# ***SOMERSET NORTHERN BYPASS PULASKI COUNTY, KENTUCKY***

Item Number 8-59.60

**VALUE ENGINEERING STUDY  
for  
Kentucky Transportation Cabinet  
Frankfort, Kentucky**

**Final Report**

## SKETCH OF RECOMMENDED DESIGN

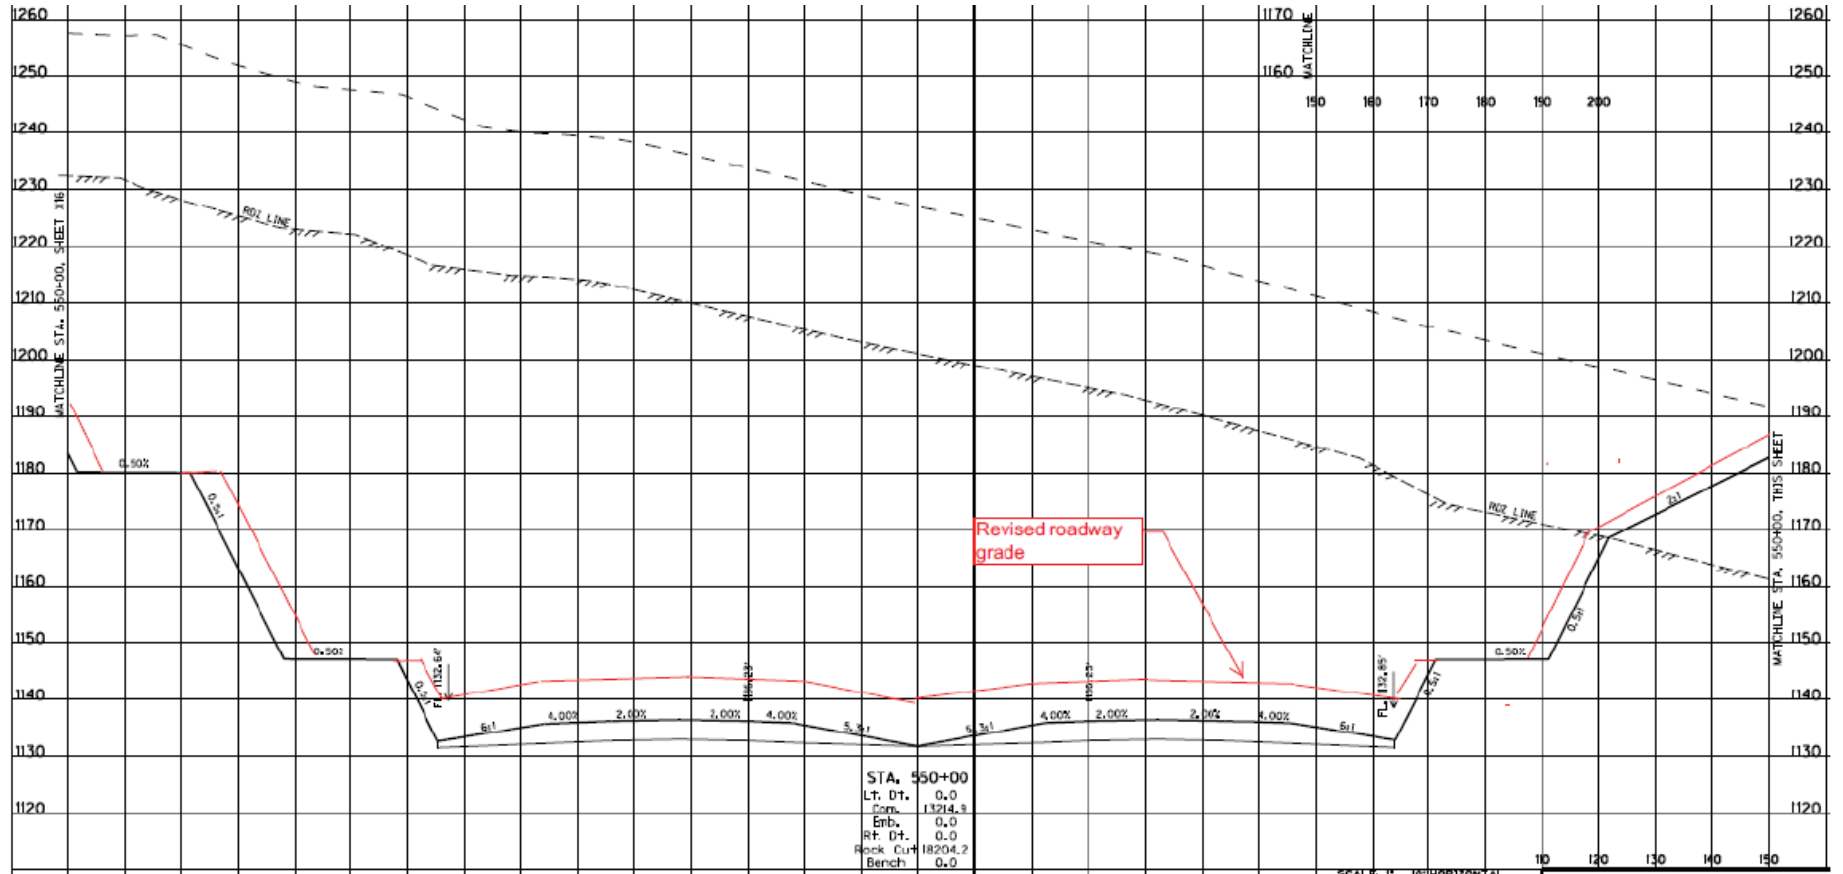
Revise profile grade in order to minimize excavation.

The VE team recommends revising the vertical alignment on Section 4A to raise the grade through the two major cuts on project. In this study the profile grade is changed from beginning of project to Station 638+00. This would reduce roadway excavation by approximately 125,500 cubic yards. The quantities included in this study are based on **only** one alternative vertical alignment. A further in-depth evaluation of different vertical alignment adjustments will possibly provide more decrease in total excavation and better overall earthwork balance. The proposed revision does also raise grade in embankment area from approximately Station 557+00 to Station 566+00 which will require additional right-of-way in this section.

## VALUE ENGINEERING RECOMMENDATION # VE-7

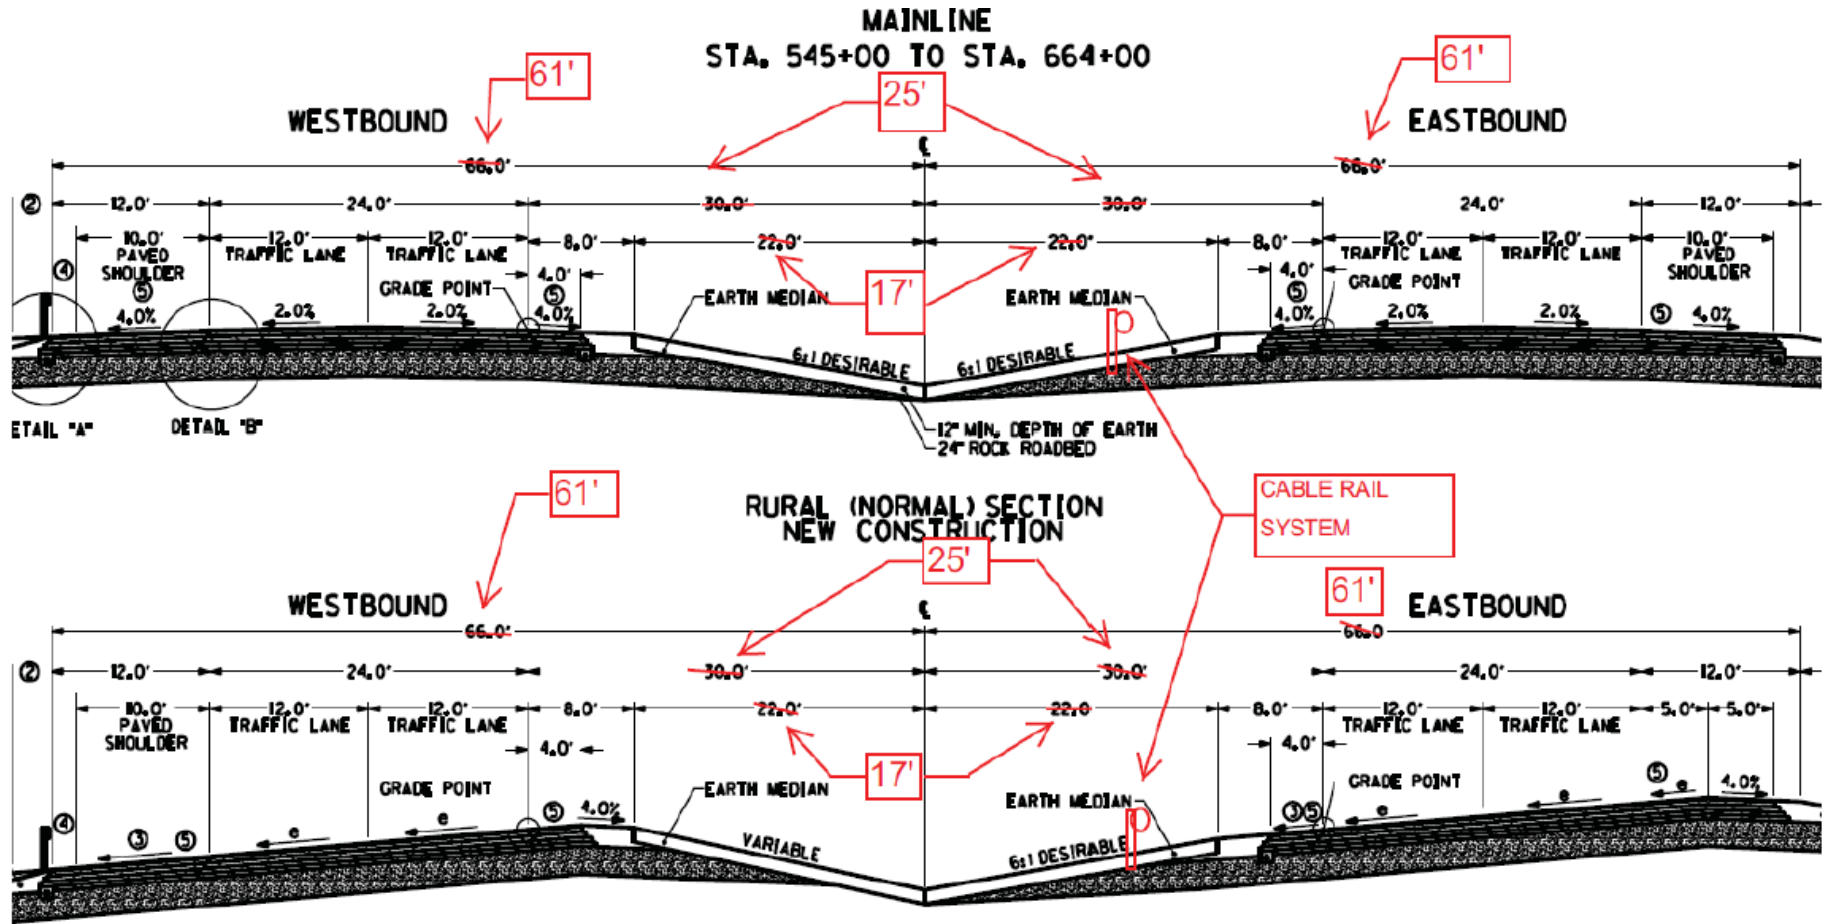
Utilize a 50 ft median with cable barrier in lieu of 60 ft depressed median section through the entire Section 4.

The VE team recommends reducing depressed median section from 60 feet wide to 50 feet wide and to add a cable barrier system throughout mainline section. This 10 foot reduction in template width will decrease both excavation and embankment volumes. The Roadside Design Guide allows the use of 50 foot median width for this type of facility with a barrier being an optional component. Due to current use of cable barrier by the KYTC on selected roadways, it would be appropriate to install barrier for this proposed project.

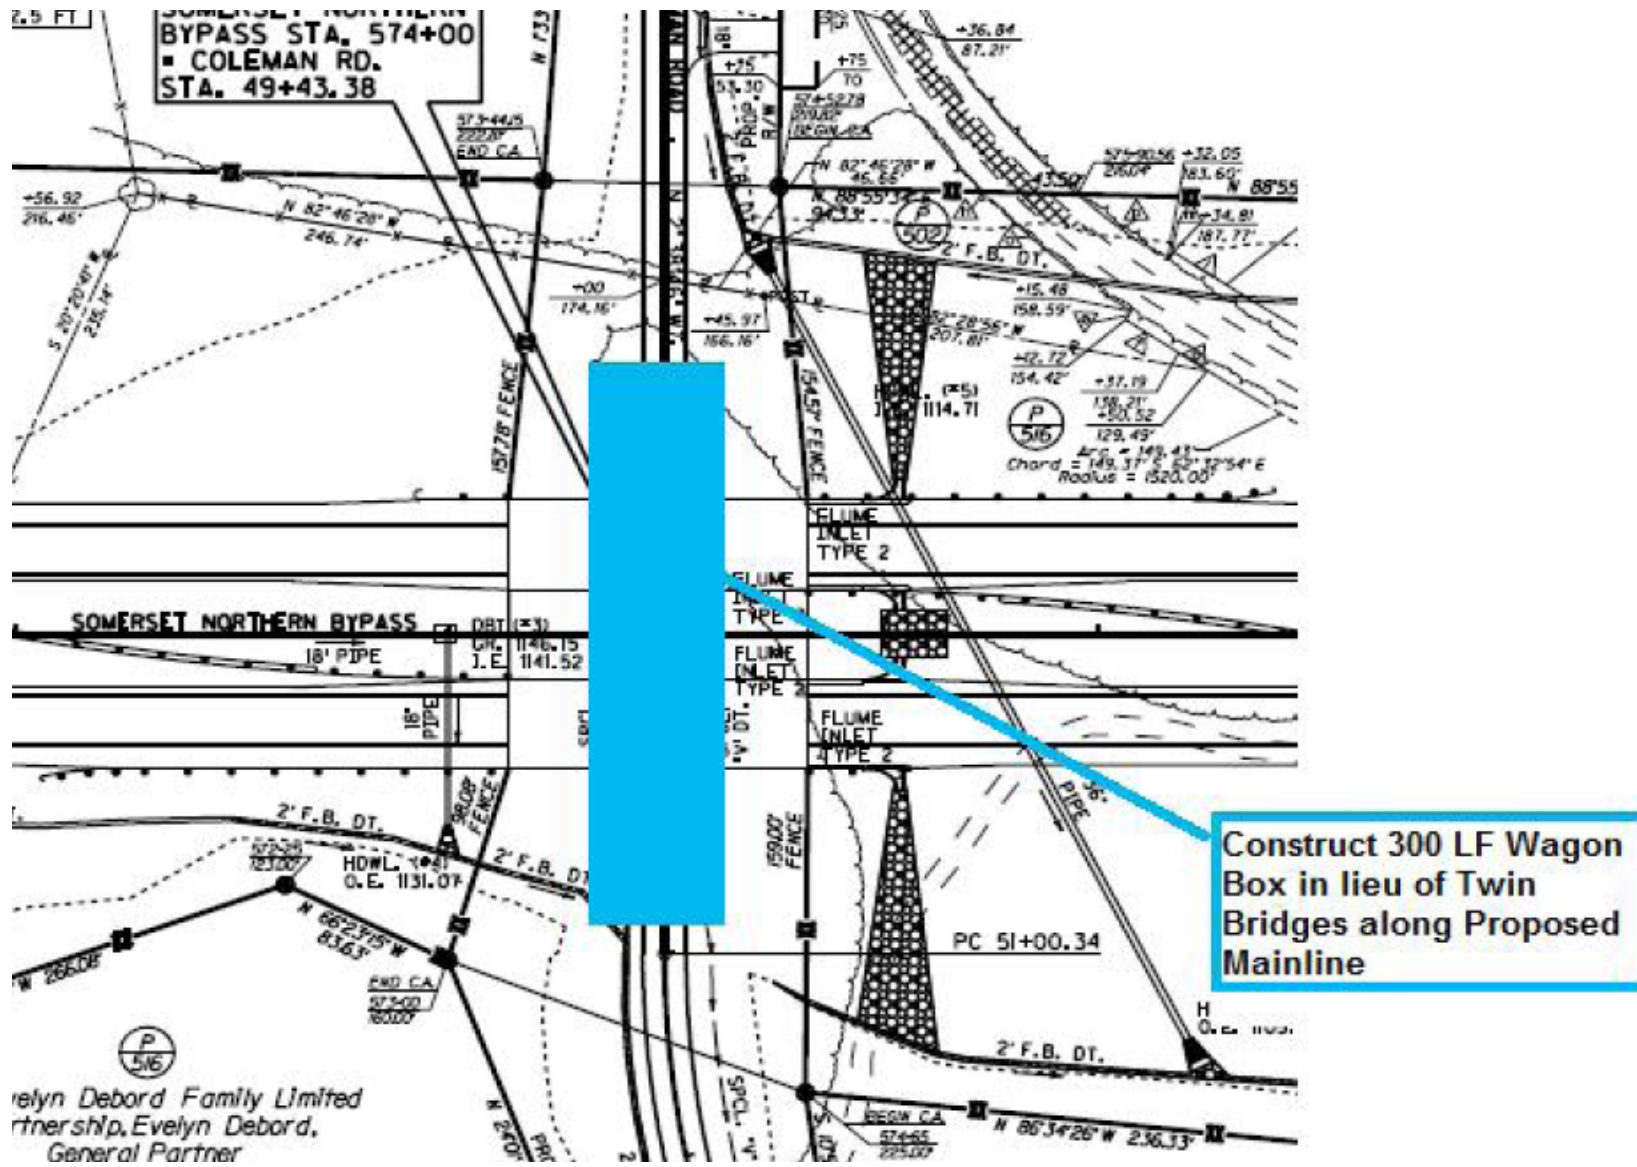
The original design specifies utilizing twin bridge structures (each structure 136 feet long) over the proposed re-alignment of Coleman Road at mainline station 574+00. The total re-alignment length of Coleman road is 2,950 feet. From the proposed plans provided to the VE team, the proposed estimate for the re-alignment of Coleman Road comes to a total of \$1,346,840. Subtracting the cost of the twin bridge structures on mainline over proposed Coleman Road is a total of \$830,000 for both, with the cost of each structure being \$415,000/bridge (\$69.35/SF). Taking the cost difference of the twin bridge structures yields a difference of \$516,840 for the proposed Coleman Road, which equates to \$175.20/ft over a length of 2,950 feet. The total estimate of \$516,840 is for all construction items supplied and depicted on the estimate supplied to the VE team but does not include any potential right of way and/or utilities.

The wagon box will still serve the purpose and need of the project by allowing traffic to pass thru the wagon box under the mainline with no disruption to the flow of traffic. Substituting the wagon box in lieu of the twin bridge structures has the potential to save the Commonwealth of Kentucky construction money to be used on similar projects.

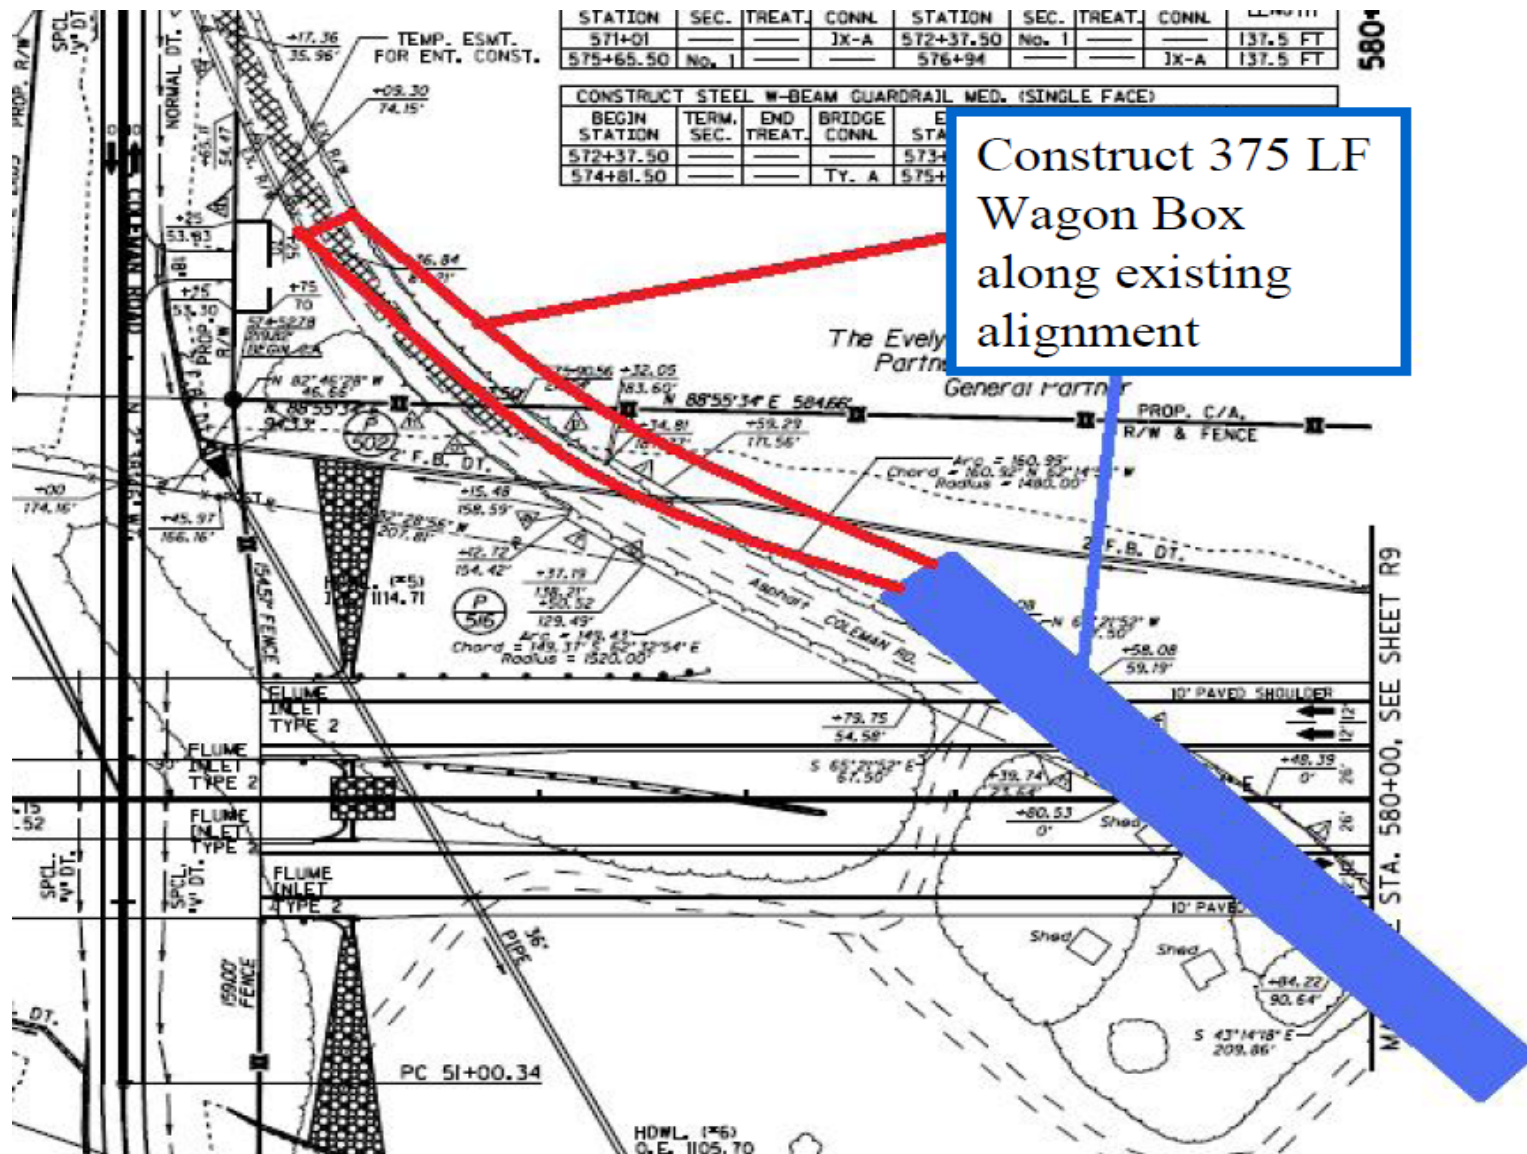
The original design specifies utilizing twin bridge structures (each structure 136 feet long) over the proposed re-alignment of Coleman Road at mainline station 574+00. The total re-alignment length of Coleman road is 2,950 feet. From the proposed plans provided to the VE team, the proposed estimate for the re-alignment of Coleman Road comes to a total of \$1,346,840. Subtracting the cost of the twin bridge structures on mainline over proposed Coleman Road is a total of \$830,000 for both with the cost of each structure being \$415,000/bridge (\$69.35/SF). Taking out the cost of the twin bridge structures yields a difference of \$516,840 for the proposed Coleman Road, which equates to \$175.20/ft over a length of 2,950 feet. The total estimate of \$516,840 is for all construction items supplied and depicted on the estimate supplied to the VE team but does not include any potential right of way and/or utilities.

The wagon box will still serve the purpose and need of the project by allowing traffic to pass thru the wagon box under the mainline with no disruption to the flow of traffic. Substituting the wagon box in lieu of the twin bridge structures has the potential to save the Commonwealth of Kentucky construction money to be used on similar projects.

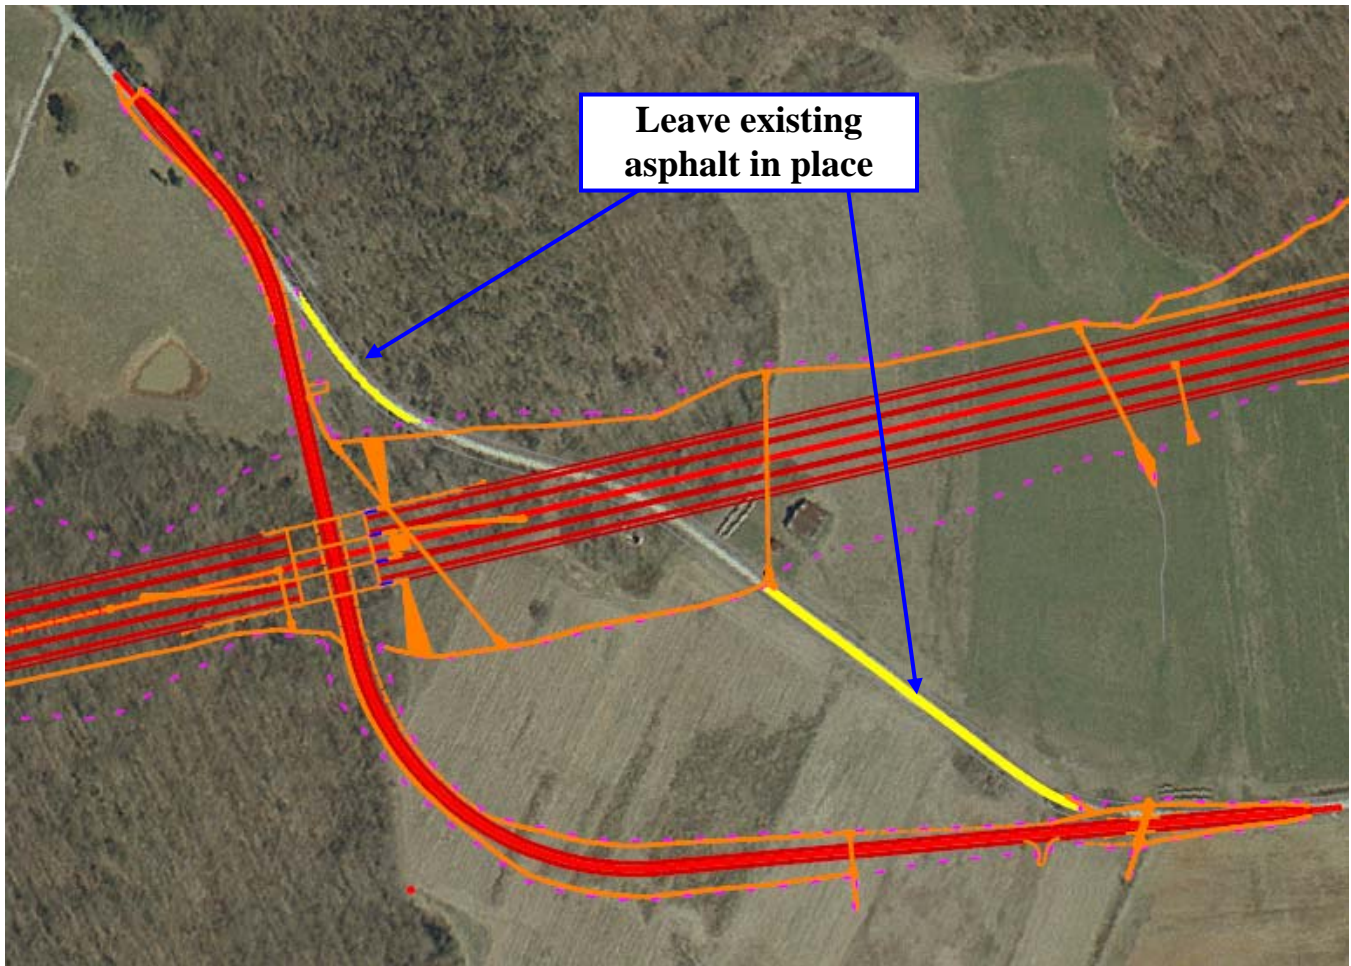
The abandoned section of Coleman Roadway is not intended for any further use or function. The VE team recommends leaving the pavement in place, because it does not need to be disturbed. If this pavement is removed, seeding and protection from erosion becomes required. Although the cost savings is relatively minor at \$18,000, this recommendation is easy to implement and would eliminate construction work and the associated duration.

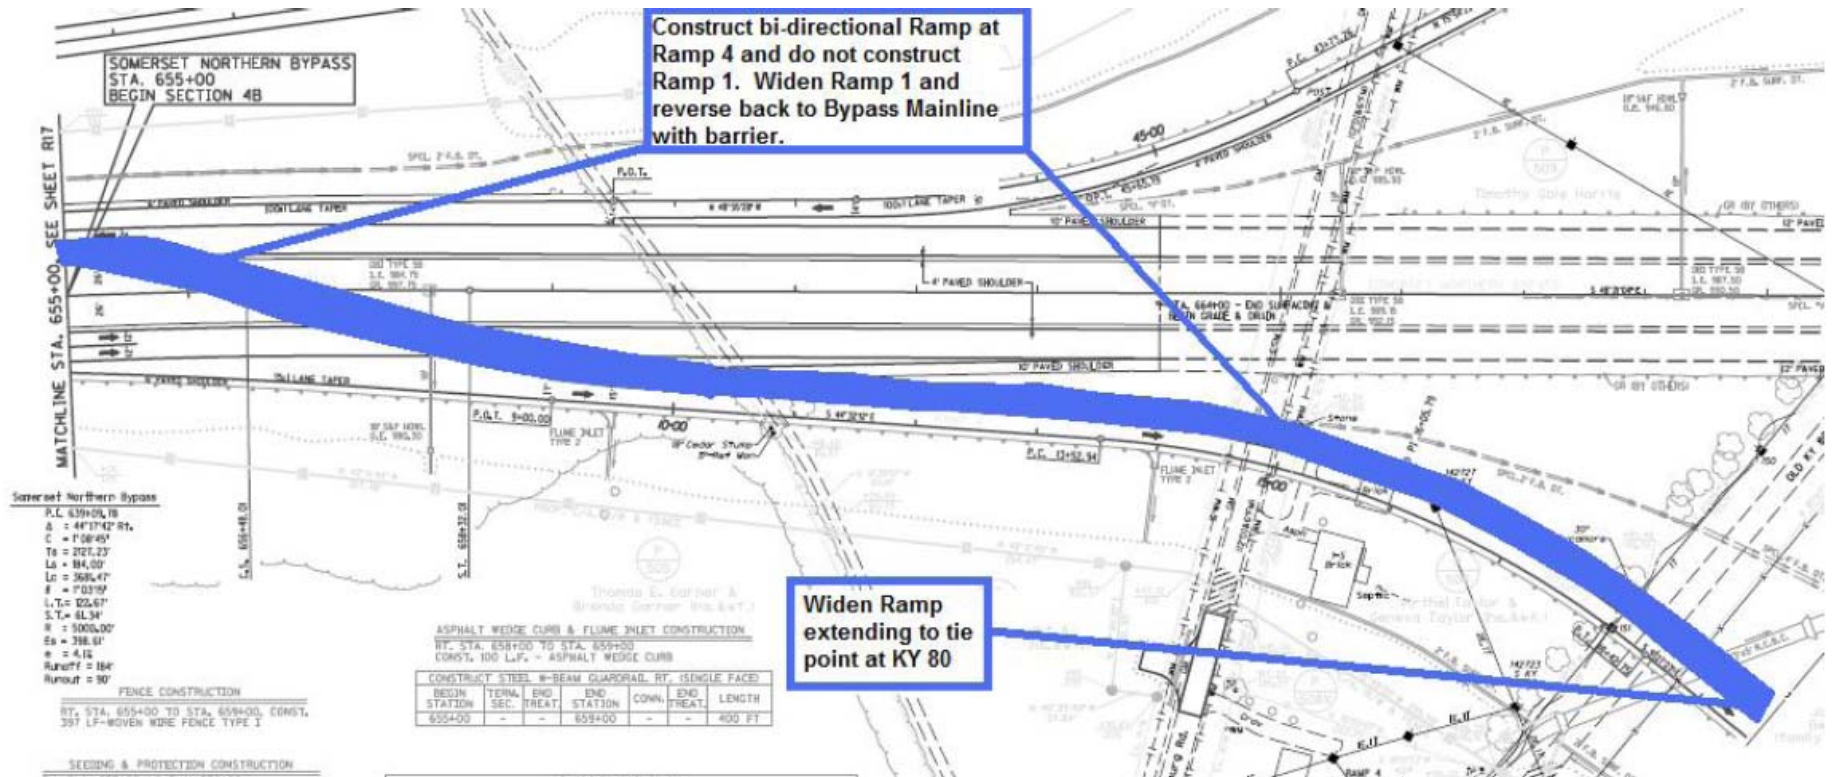
The VE team recommends constructing a bi-directional two way ramp along Ramp 4 and not constructing Ramp 1 until a possible future project. Ramp 4 will provide access for westbound motorists to access the bypass by entering and exiting at Ramp 4 and crossing over the median to proceed into the westbound lanes. All motorists along KY-80 will enter and exit the bypass at the same point.

By widening Ramp 4 to 2 lanes separated by a median barrier will reduce increased cost associated with all proposed items relating to Ramp 1 which can be incorporated into a future phase. With the construction of Ramp 1 at a later date will allow the contractor to stock pile excess material on site at the proposed Ramp 1 location.
